ATTACHMENT (1)

TECHNICAL SPECIFICATION CHANGE

CALVERT CLIFFS - UNIT 1

FIGURE 3.4-2a
 CALVERT CLIFFS UNIT 1 HEATUP CURVE, 12 EFPY
 REACTOR COOLANT SYSTEM PRESSURE TEMPERATURE LIMITS

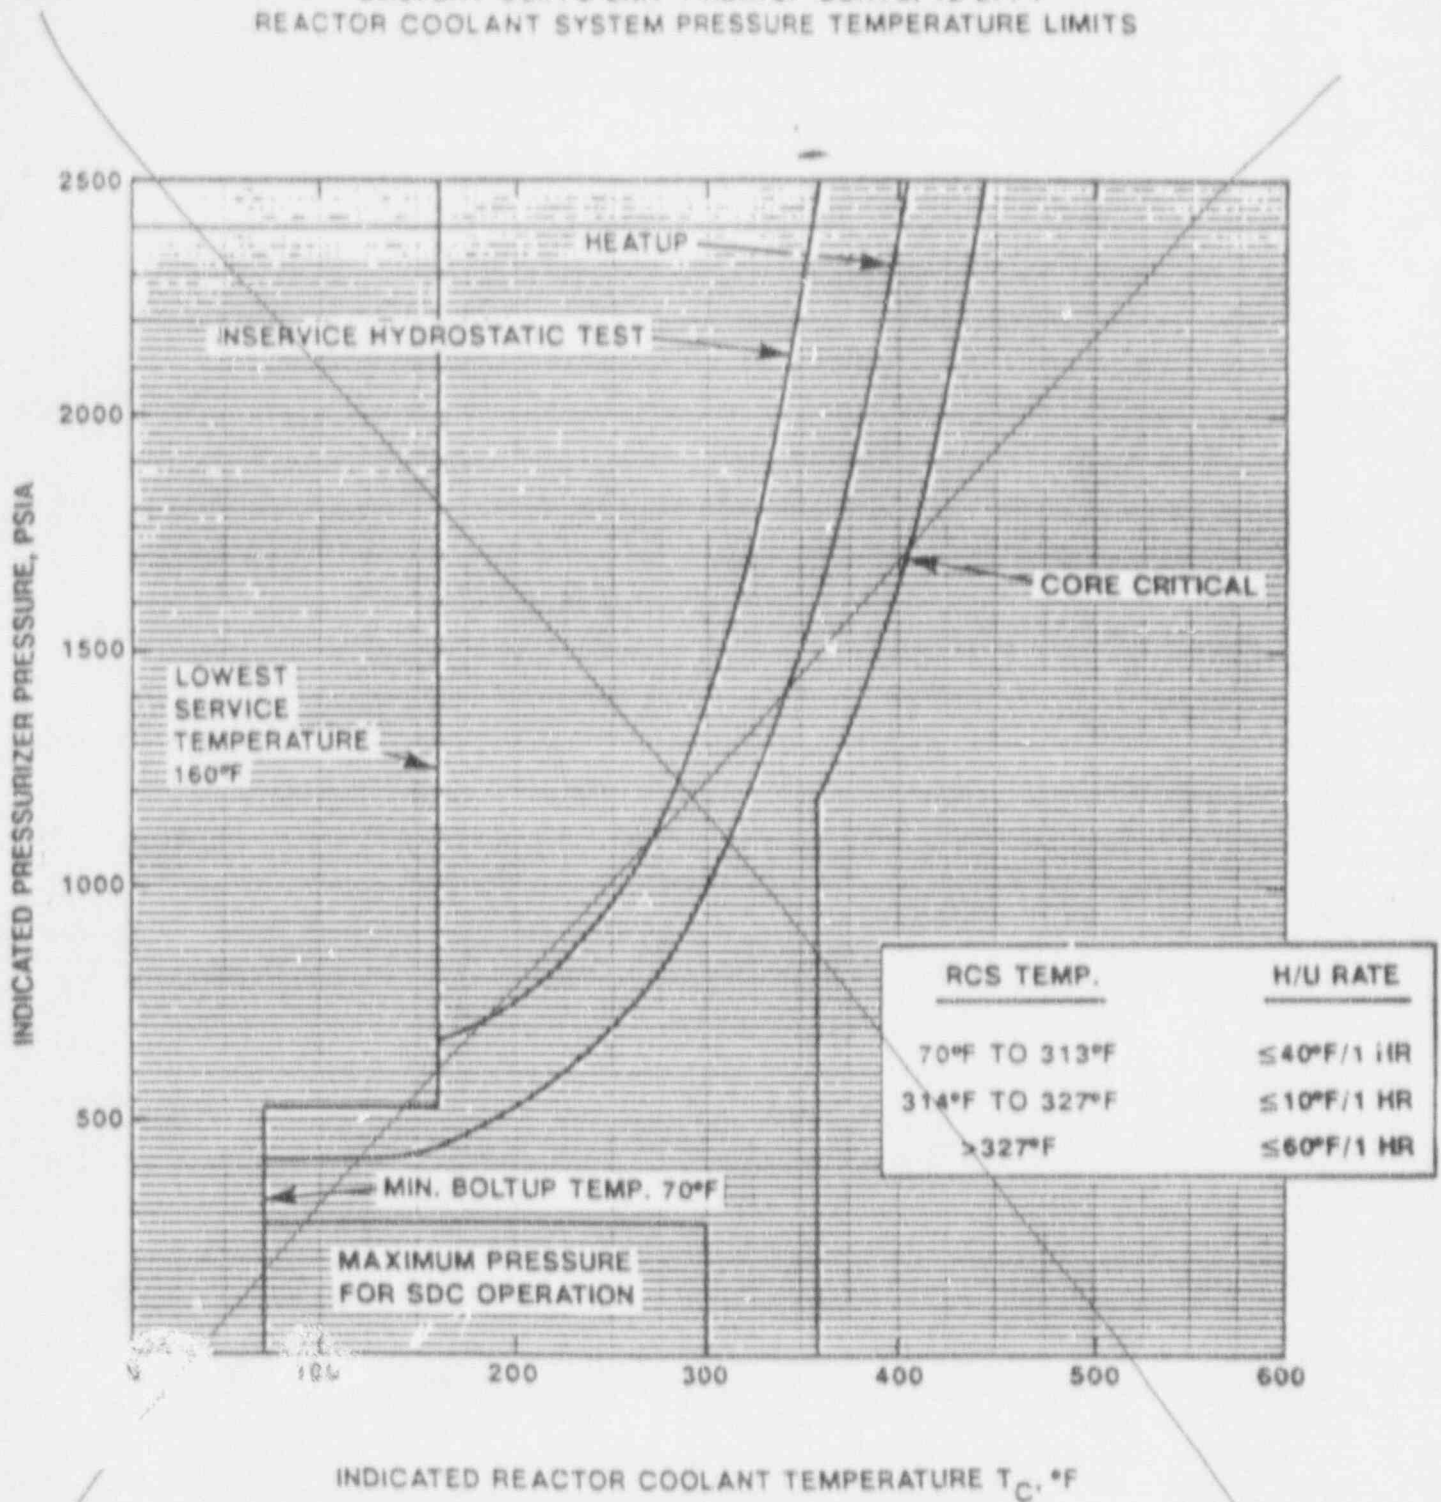
4.4.9.1.2 The reactor vessel material irradiation surveillance specimens shall be removed and examined, to determine changes in material properties, as required by 10 CFR Part 50, Appendix H. The results of these examinations shall be used to update Figure 3.4-2.

FIGURE 3.4-2a
 CALVERT CLIFFS UNIT 1 HEATUP CURVE
 REACTOR COOLANT SYSTEM PRESSURE TEMPERATURE LIMITS
 FOR FLUENCE $\leq 3.25 \times 10^{19}$ n/cm² AT THE INNER SURFACE OF THE REACTOR VESSEL

FIGURE 3.4-2b
 CALVERT CLIFFS UNIT 1 COOLDOWN CURVE, 12 EPY
 REACTOR COOLANT SYST 'M PRESSURE TEMPERATURE LIMITS

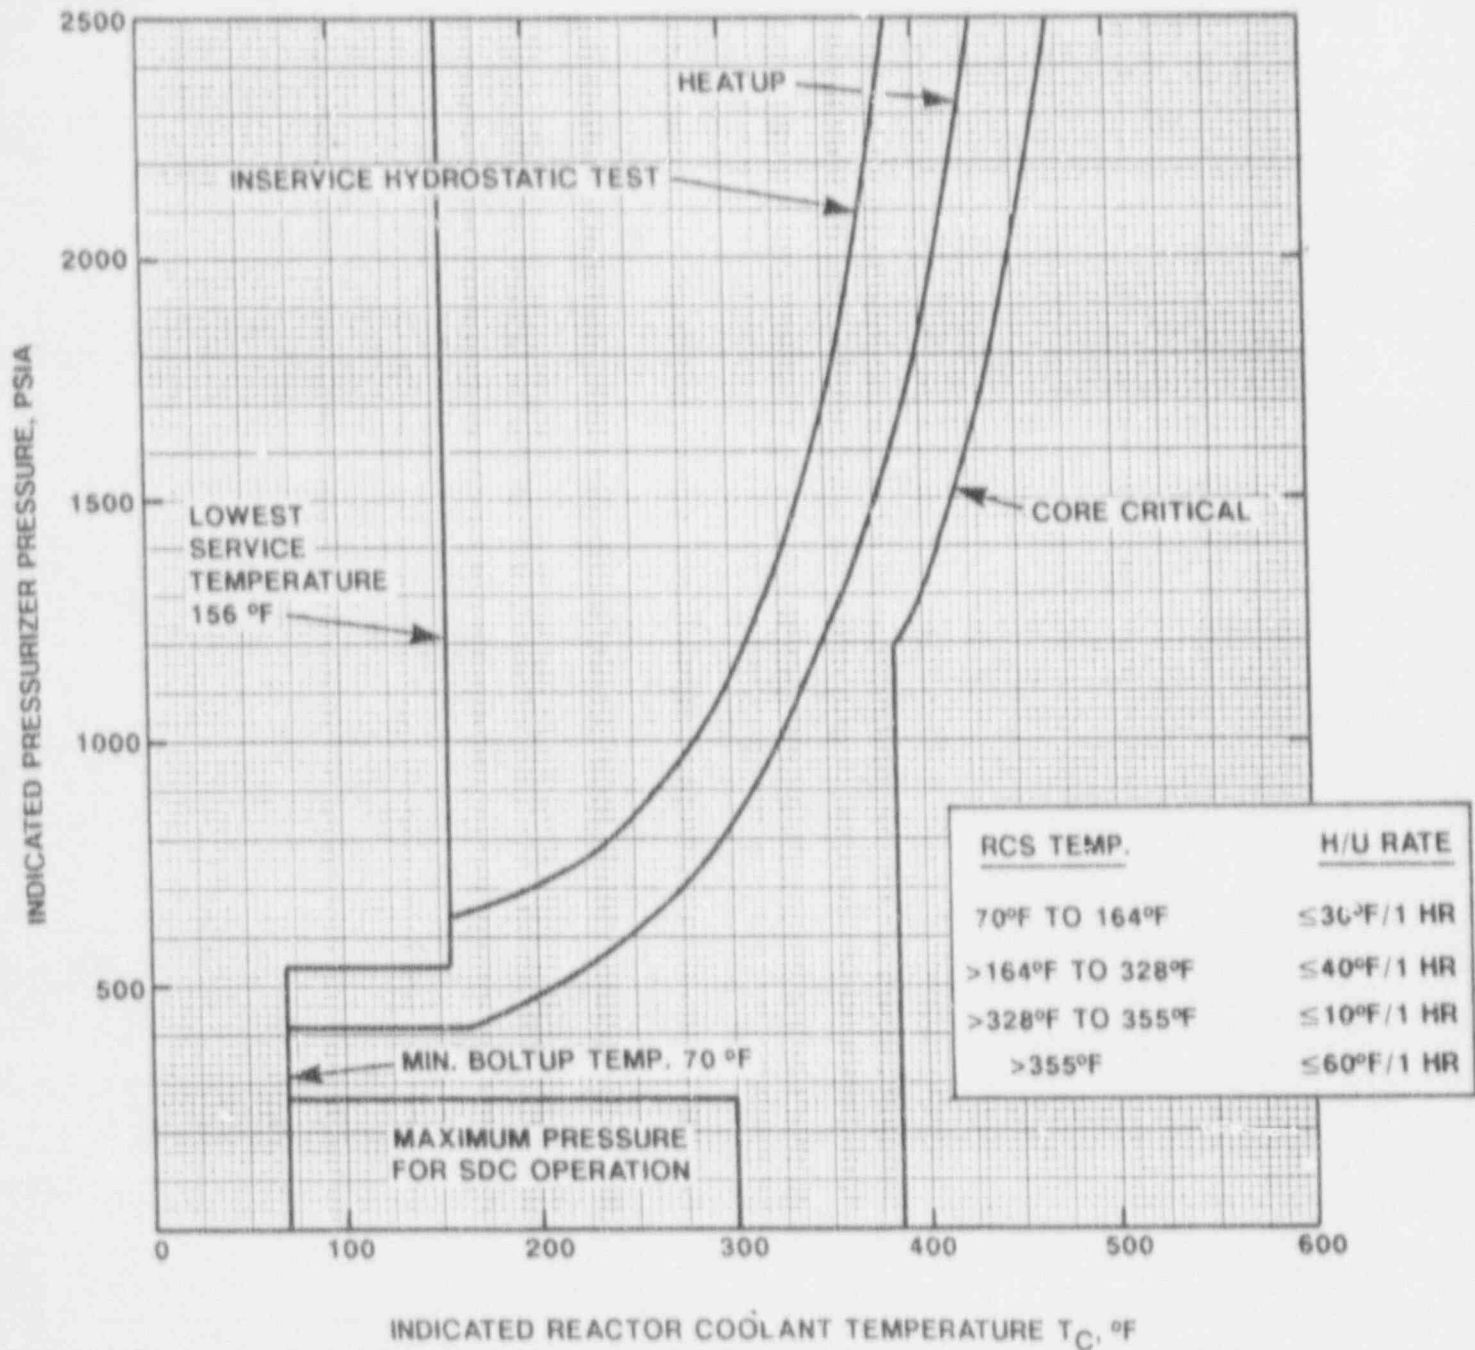
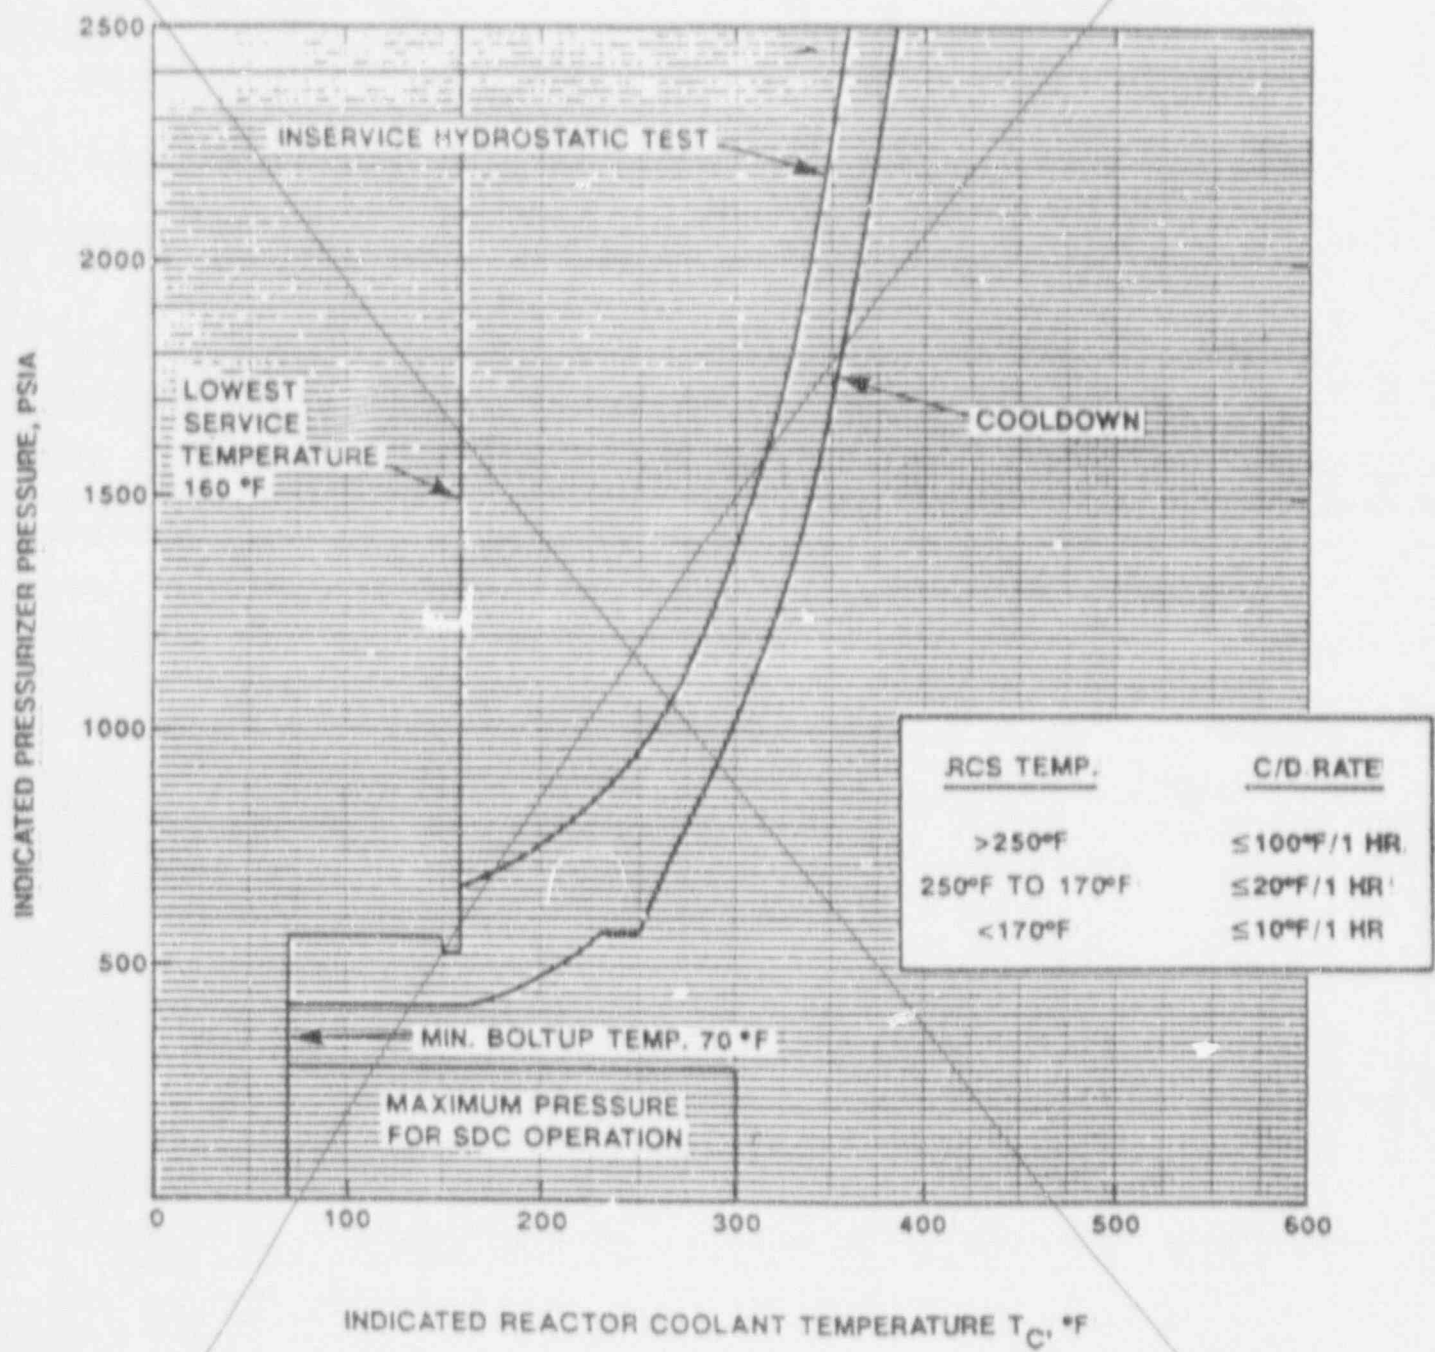
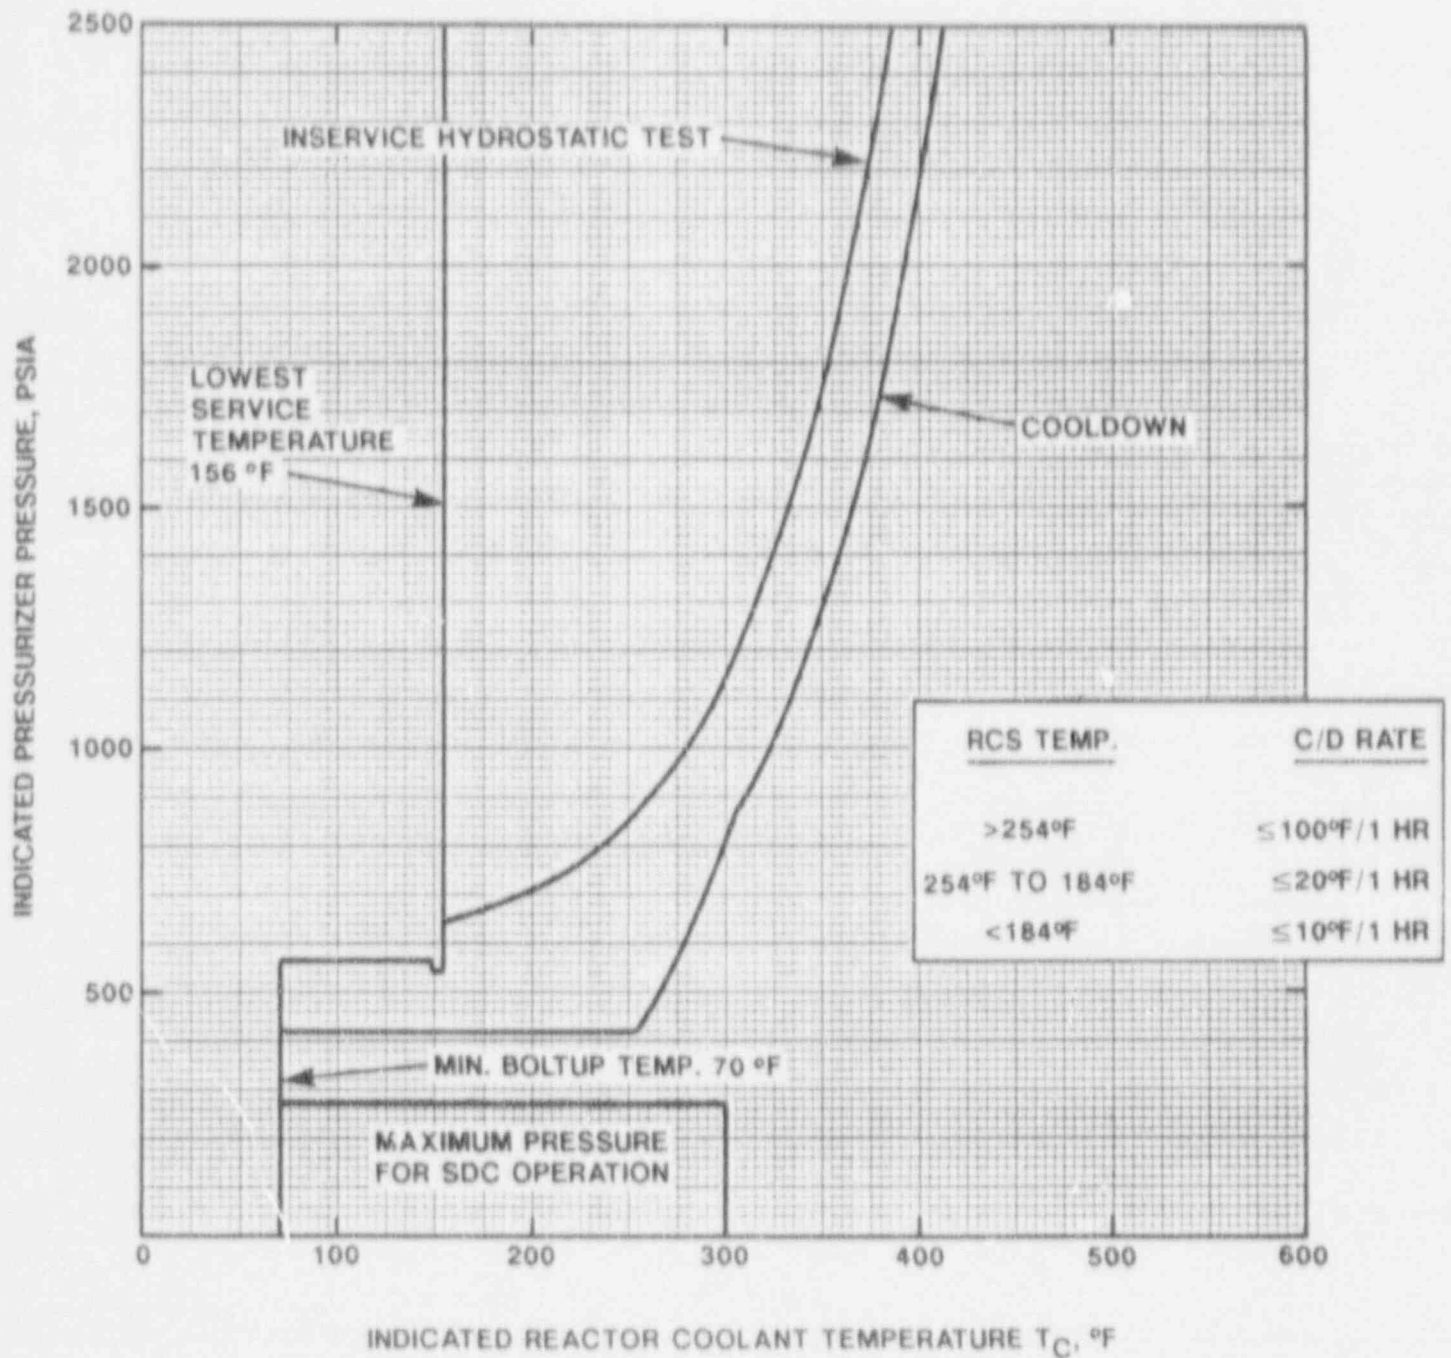
FIGURE 3.4-2b
 CALVERT CLIFFS UNIT 1 COOLDOWN CURVE
 REACTOR COOLANT SYSTEM PRESSURE TEMPERATURE LIMITS
 FOR FLUENCE $\leq 3.25 \times 10^{19}$ n/cm² AT THE INNER SURFACE OF THE REACTOR VESSEL
